ADDENDUM NO. 1

Prospective Bidders and all concerned are hereby notified of the following amendments and interpretations to the Contract Documents of the I-195 REDEVELOPMENT DISTRICT for the PARCEL 28 TEMPORARY PARKING. These amendments and interpretations shall become an integral part of the Contract Documents. The number and date of this addendum must be entered into the space provided on the Bid Form.

I-195 REDEVELOPMENT DISTRICT
 SITE PLAN
 PARCEL 28 TEMPORARY PARKING LOT
 PROVIDENCE RHODE ISLAND

Sheet CS-101 Revision date January 11, 2019

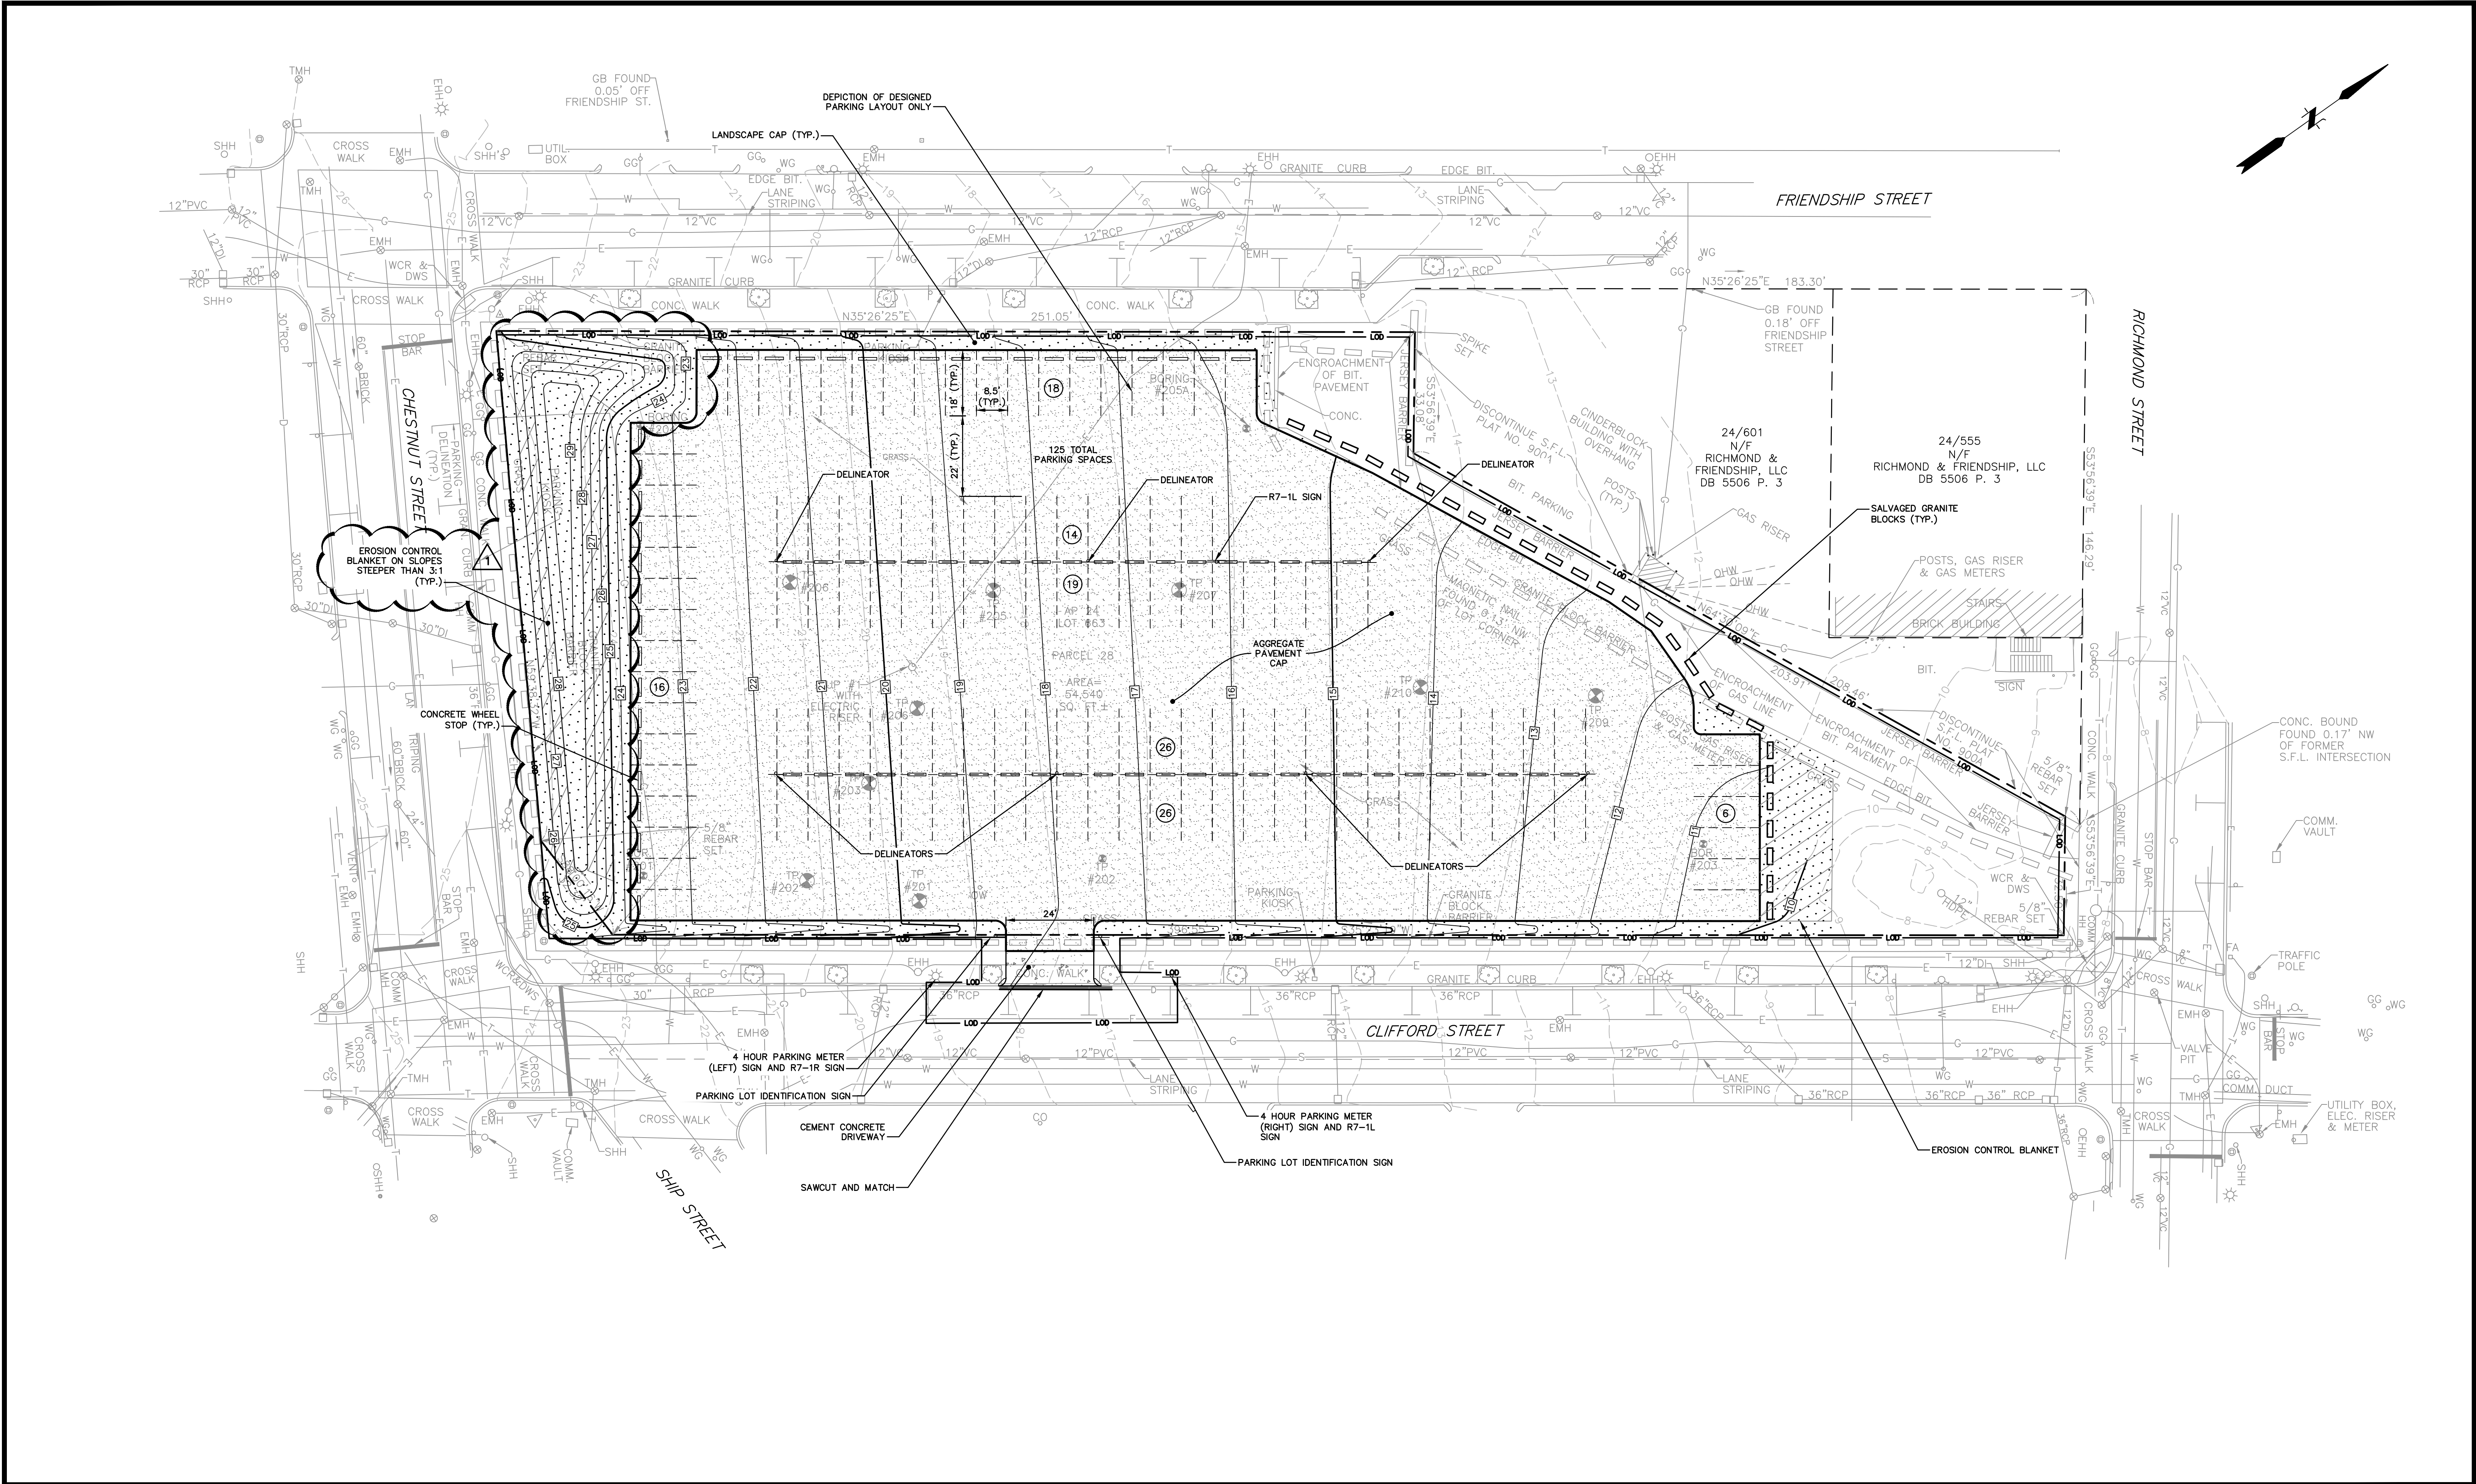
1. Are concrete wheel stops required at interior parking spaces?

1. A revised Sheet CS-101 of the drawings is included as a part of this addendum as Exhibit A.

Response: Concrete wheel stops are required at both perimeter and interior parking spaces as detailed on Sheet CS-101 of the drawings.

No.	DATE	DESCRIPTION	DESIGNER	REVIEWER
1.	1/11/2019	EROSION CONTROL BLANKET	CV	PD
